## **DETAILED ACTION**

Application/Control Number: 10/590,511  
Art Unit: 4171

**Above figure- Applicants actuator.**

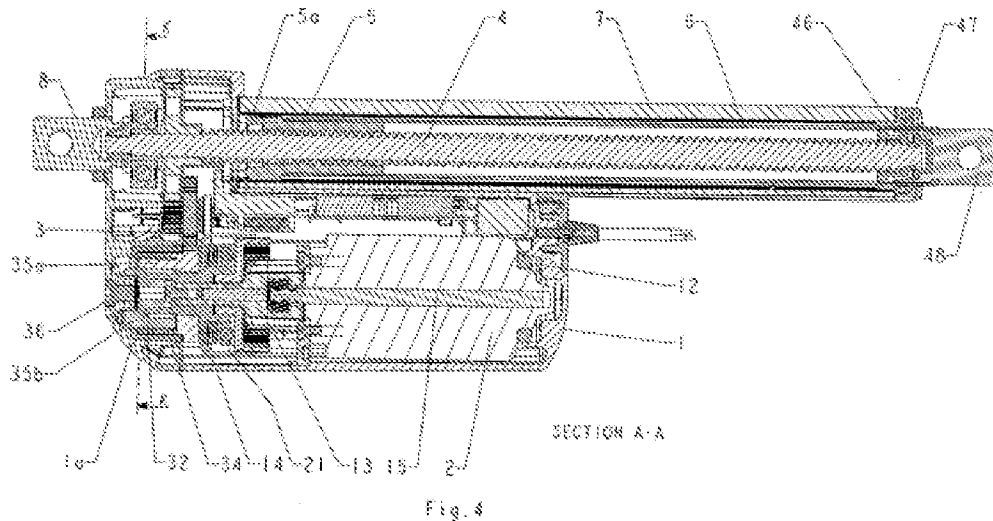
***Regarding claim 1,***

Applicant claims a linear actuator (fig. 1,10; Examiner notes prior art is a jack which has the same structure as the claimed actuator and functions as a linear actuator) comprising:

- A cabinet (fig.1, 22 or 24) having
- A reversible electric motor (fig. 2, 60 and col.6, lines 24-25; Examiner notes an electric motor is clearly capable of being reversible by switching the current) with a motor shaft (fig.2, 62),

- A reduction gear (fig.2, 64,66,76), where a first stage (fig.2, 64) is connected with the motor shaft as seen in fig.2,
- A spindle (fig.2, 88) whose one end is connected with an output side on the last stage of in the reduction gear (fig.2, 76) and the other end indicates the front of the actuator,

- A spindle nut (fig.2, 114; Examiner notes, prior art calls this a ball follower since its a ball screw) secured against rotation and translates linearly along the spindle (col.6, lines 13-15),

- A rear mount (fig.1, 14 and 20)
- An overload clutch (fig.2, 82, and col.6, lines 56-58) wherein the overload clutch is connected to one of the first stages in the reduction gear (fig.2; connected to gears 76,66,64).

Above figures- Whittingham's invention.

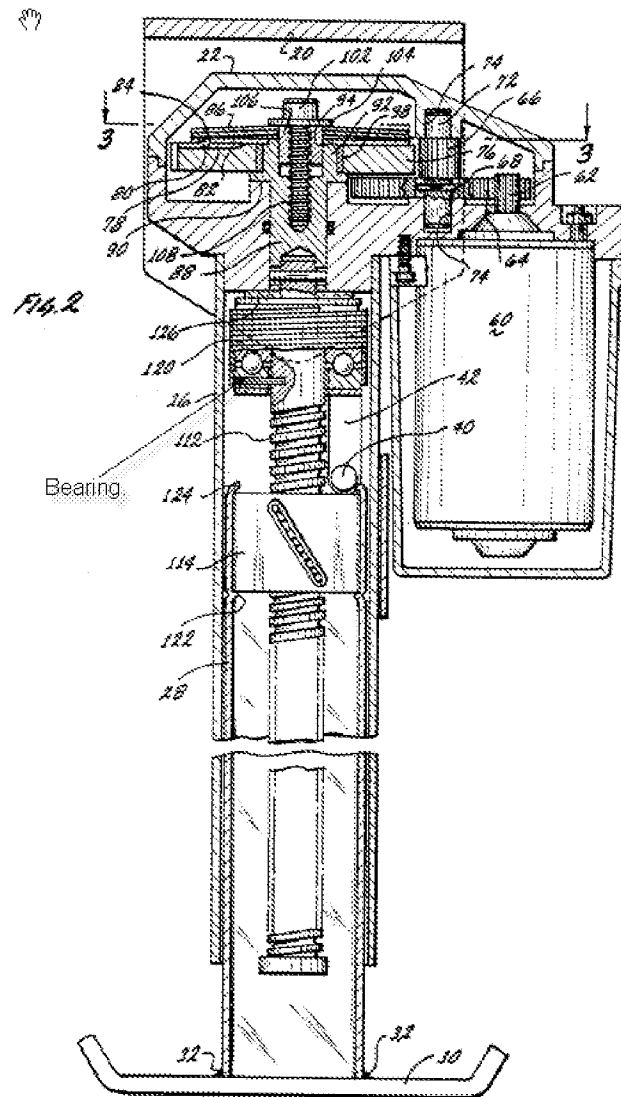
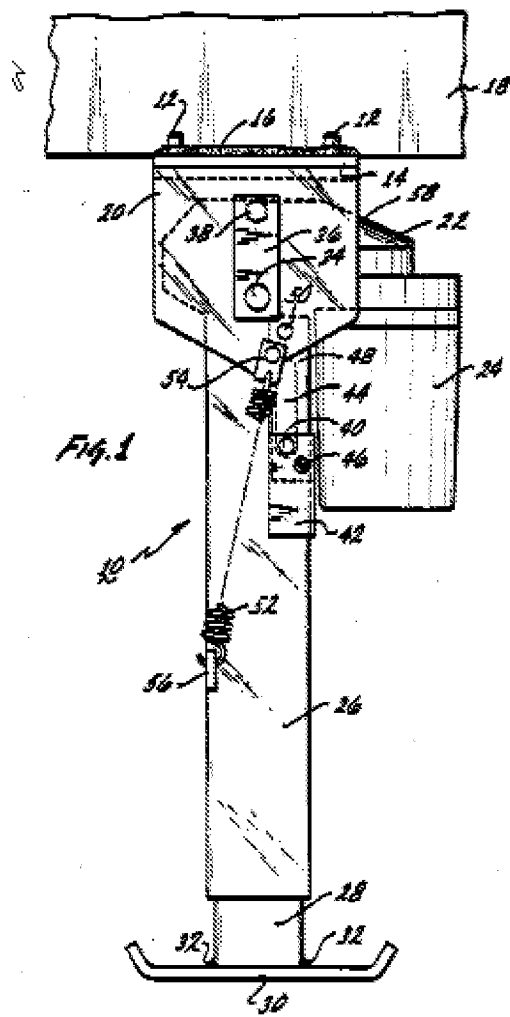
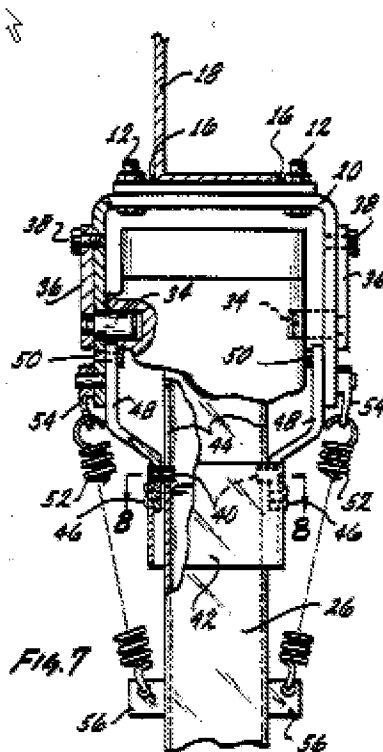
***Regarding claim 6, as best understood,***

Applicant claims that the rear mount and a bearing (fig. 2, labeled by examiner) are secured in a mounting element (fig.1, 20) consisting of two parts (fig.7, 36) which are mounted in a depression in the cabinet (fig.7, shows how element 36 is mounted through pins 34 into the depressions in the cabinet) and secured with a nut (fig.7, 12) screwed on to the part of the rear mount that protrudes through the cabinet (fig.7, element 20 is part of mount that protrudes the cabinet as described above).

Above figure- Whittingham's invention.

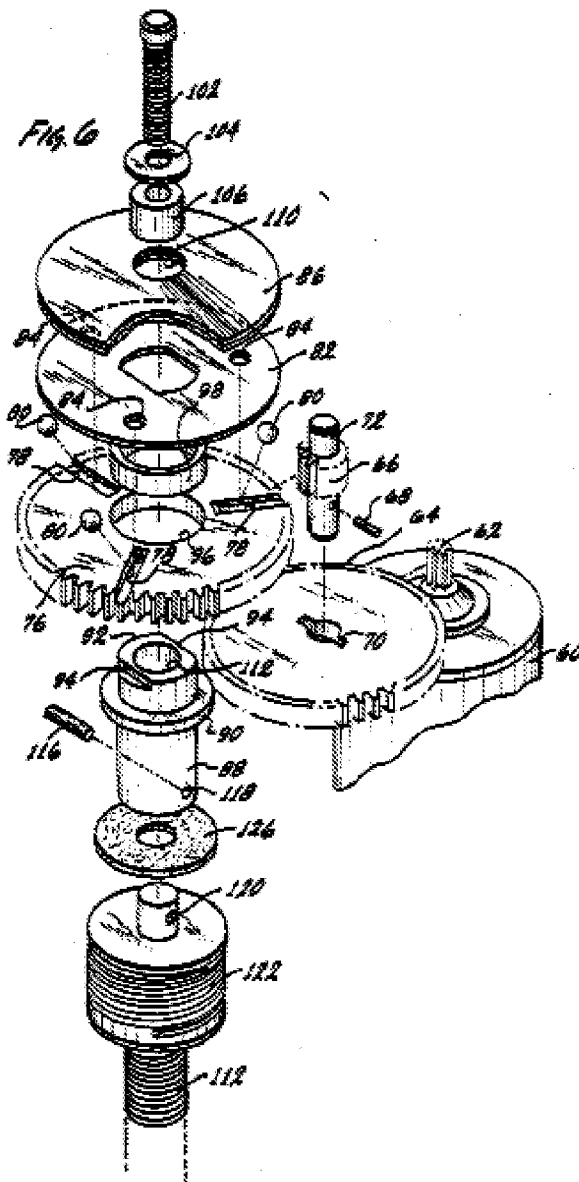
***Regarding claim 2,***

Applicant claims the overload clutch is a ball and ratchet clutch (fig.2; Examiner notes the prior art doesn't call their clutch by the same name but it has the same structure and therefore is the same type of clutch) comprising:

- a ring with holes (fig.6, 82)
- a first plate (fig.6, 76) with depressions (fig.6, 78) that engage the balls (fig.6, 80) and is firmly connected to the transmission from the motor (fig.2, the gear 76 is connected to the transmission of the motor),
- a second plate with depressions that engage another side of the balls which Whittingham fails to disclose,
- a spring mounted against the ceiling in a cap (fig.2, spring 86 mounted against the ceiling of a cap 94. Examiner takes the position that washer 94 acts as a cap on the spring because it covers it.),
- wherein the cap is secured indirectly to the first plate member (seen in fig.2, the cap is secured to the first plate member through bolt 102), and
- wherein the ring with the balls is connected with the further transmission to the spindle (fig.2, gear 76 being part of the transmission and the spindle is disposed through the ring.)

**FIG. 9**  
(PRIOR ART)

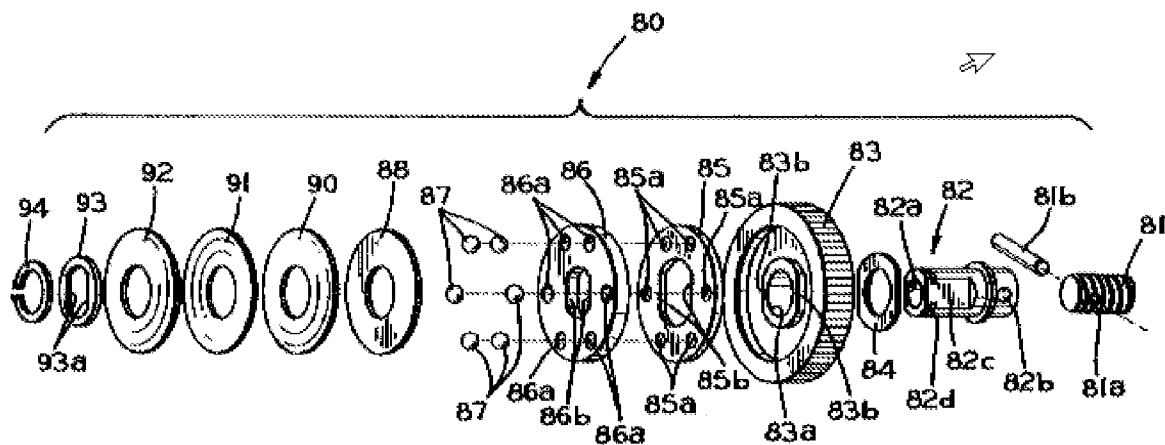
***Regarding claim 2,***

Alfano et al. teaches a linear actuator having a similar clutch system (fig.9) to the applicant's claimed invention for the purpose of limiting the amount of torque that can be transmitted from the motor to the screw assembly (see abstract) comprising:

- a ring with holes (fig.9, 83, The gear has hole for the balls and the clutch plates.)
- a first plate (fig.9, 85) with depressions (fig.9, 85a) that engage the balls (fig.9, 87) and is firmly connected to the transmission from the motor (fig.9, the gear 83 is connected to the transmission of the motor),

- a second plate with depressions that engage another side of the balls (fig.9, 86 and 86a),
- a spring mounted against the ceiling in a cap (fig.9, springs 90-92 mounted against the ceiling of a cap 94. Examiner takes the position that retaining ring 94 acts as a cap on the spring because it covers it.),

- wherein the cap is secured indirectly to the first plate member (seen in fig.9, the cap is secured to the first plate member the other members of the clutch assembly), and

- wherein the ring with the balls is connected with the further transmission to the spindle (fig.9, gear 83 being part of the transmission and a spindle (fig.9, 81) is connected to the gear 83.)

**Above figure- Akkerman's actuator.**

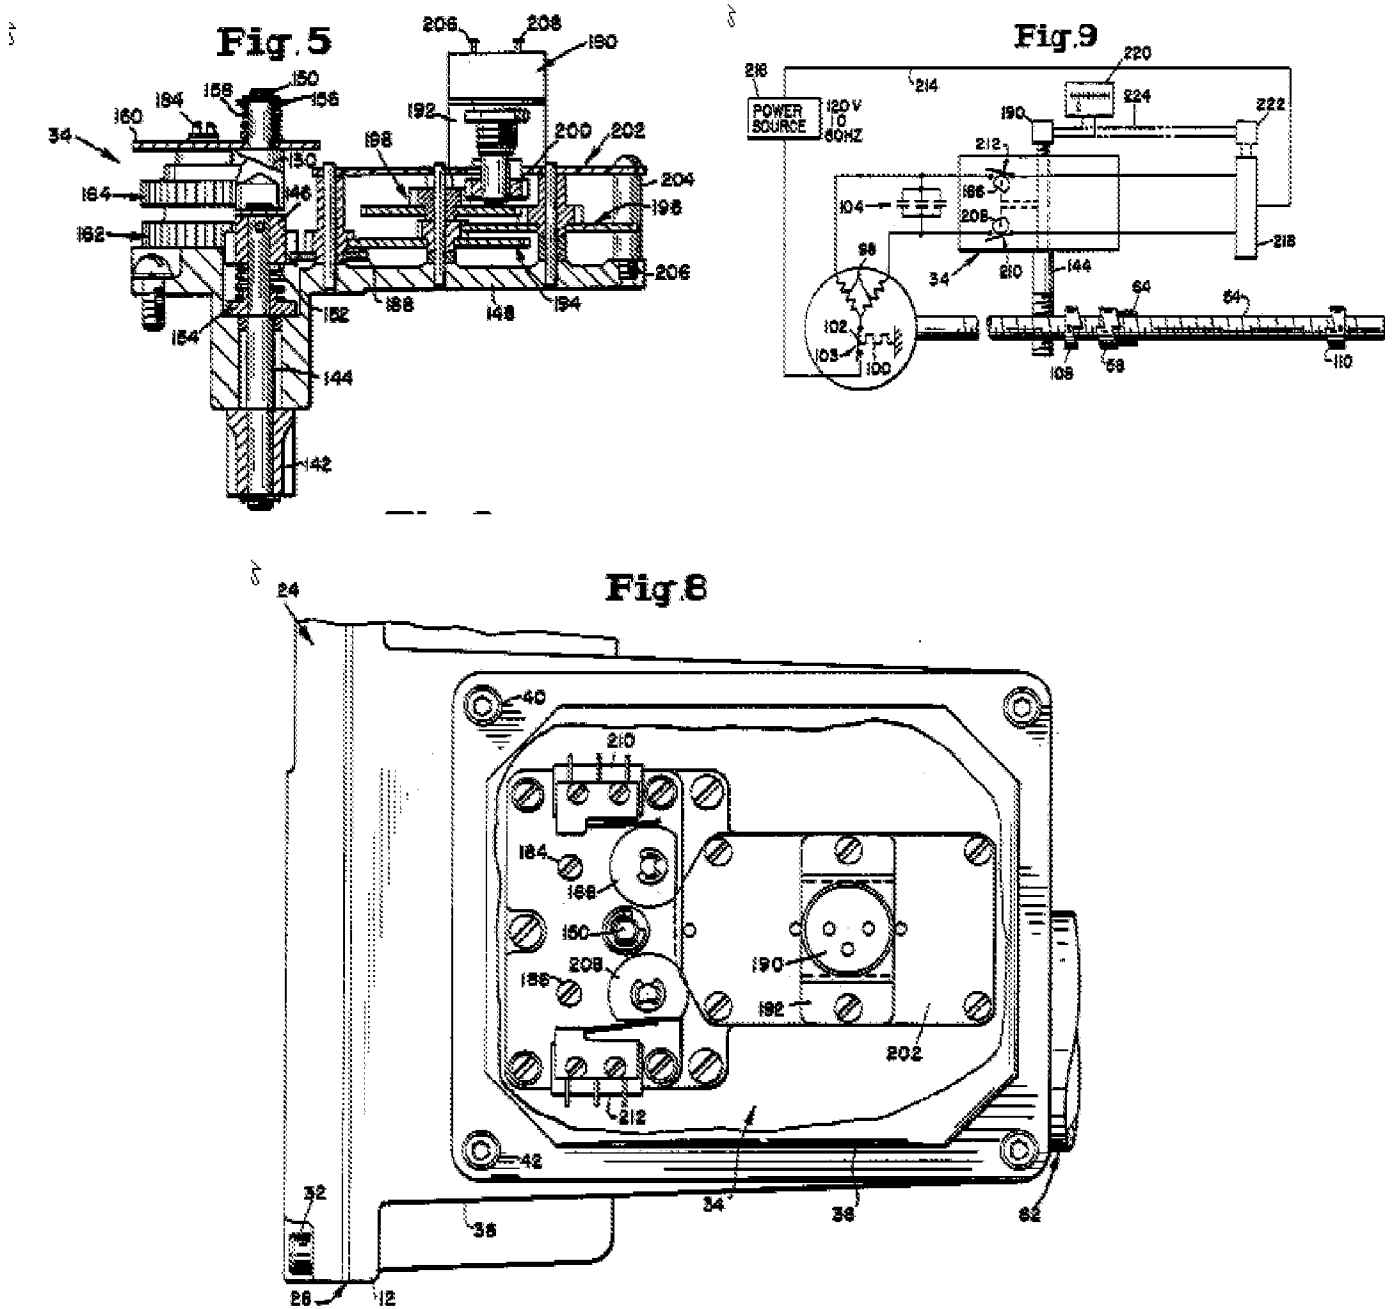
Applicant claims that the end of a shaft member or an extension thereof is configured to receive a crank through an opening in the cabinet for manual operation of the actuator.

Whittingham fails to teach an actuator configured to be manually operated with a crank.

Akkerman teaches a valve actuator configured with an opening in the housing for a crank (fig.1, 130) in order to provide a way to manually operate the actuator in case the electric motor fails (col. 5, lines 66+, col. 6 lines 1-2).
